Site Specific Traffic Control Plan for the Jamaica ER-BRF 015-1 (23) Project

Approved ER-BRF 015-1 (23) Traffic Control Plan Revision 10/2012

RESUBMIT YES Rejected

*Site Specific Traffic Control Plan
for
State of Vermont Project: Jamaica ER-BRF 015-1 (23)*

DELINEATION, BARRICADES AND DETOURS FOR CONSTRUCTION AREAS

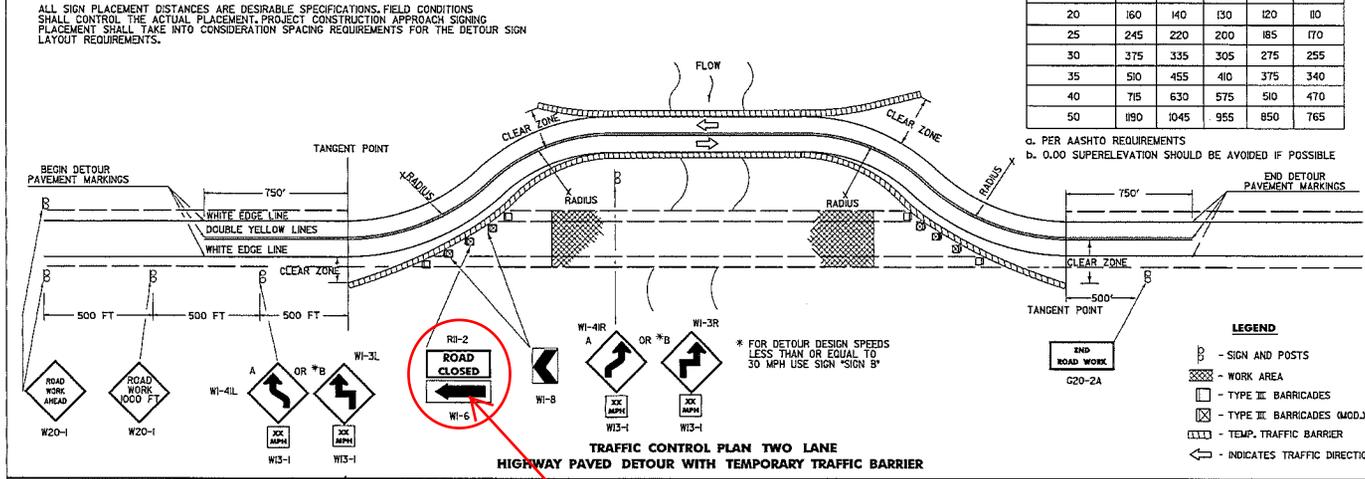
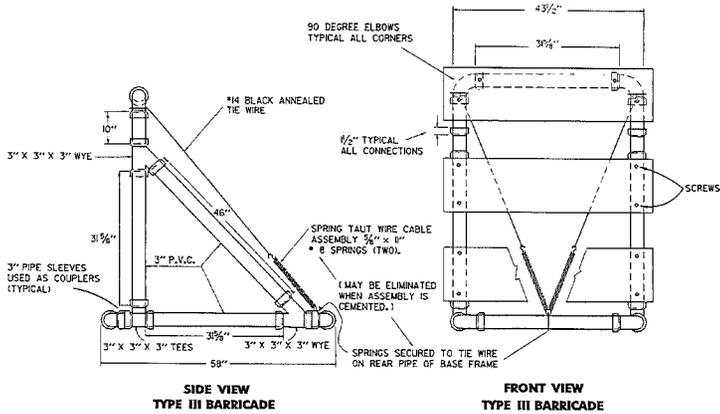
NOTE THAT MUTCD NO LONGER USES ROAD CLOSED SIGN FOR THIS SITUATION. IF THESE SIGNS ARE PRESENT ON THE EXISTING DETOUR THEY SHOULD BE REMOVED. THEY CAUSE MORE CONFUSION THAN HELP
